PORSCHE CARS NORTH AMERICA - INC.

# Technical Bulletin

**Subject:** Fuel Level Gauge Sender Replacement and/or Checking

<b>Part Identifier</b> 2015	<b>Number</b> 9101
--------------------------------	-----------------------

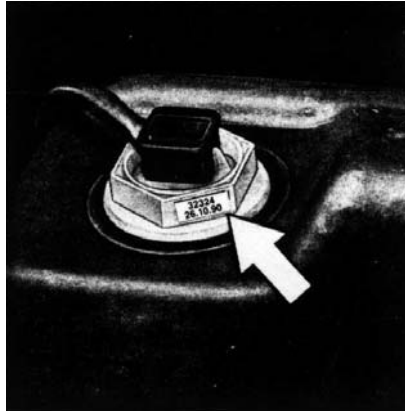
The fuel level gauge sender shown above, with production date "26-10-90" or later, **should not** be replaced if the sender is operating properly. If, however, the sender is not operating, it must be replaced with the sender components shown on page one (1). The parts set is Part Number 000 043 175 00.

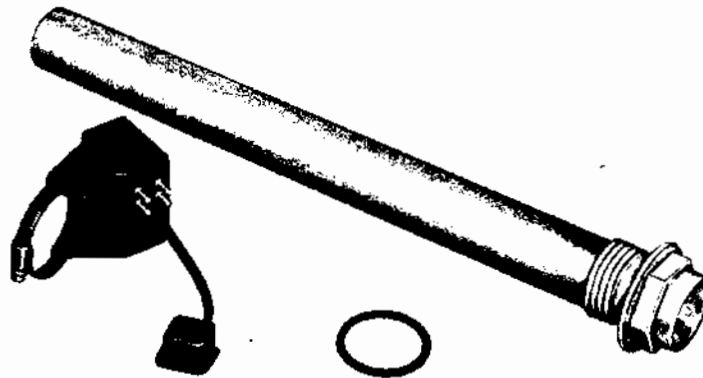
Shown above is sender components parts set, Part Number 000 043 175 00 which consists of:

Sender	964 641 801 02
Control Unit	964 641 081 00
Clamp	N 024 507 3
Sealing O-ring	999 707 115 40

A - Additional 3mm vent hole  
B - Sealing surface

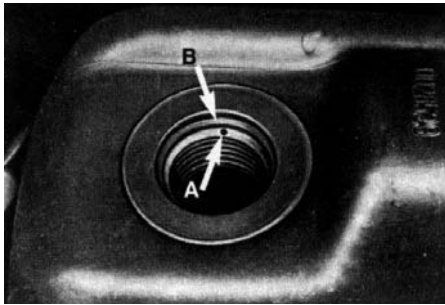
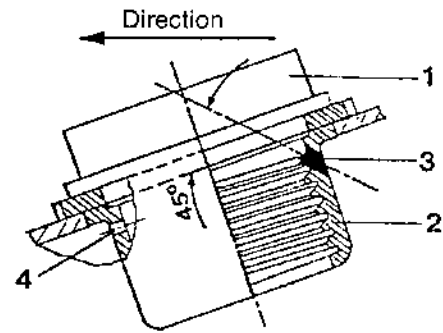
**Note:** An additional vent hole of 3mm must be drilled into the sender opening of the fuel tank to avoid any fuel gauge reading deviation at "Full".

8. Mark the position for the vent hole to be drilled as shown. The vent hole should be at the rear (relative to the direction of travel) top end of the thread, at the point of transition between the threads and the oblique surface. The sealing surface above **must not be damaged**.

Drill the required additional 3mm vent hole with a hand driven drill in a downward angle of approximately 45° as shown in the above sketch.

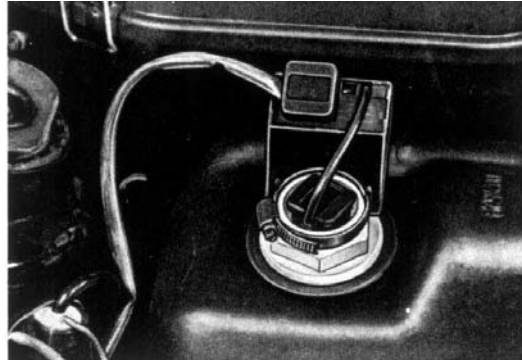
13. Fasten the electronic component with the clamp onto the sender upright, and towards to the rear as shown.
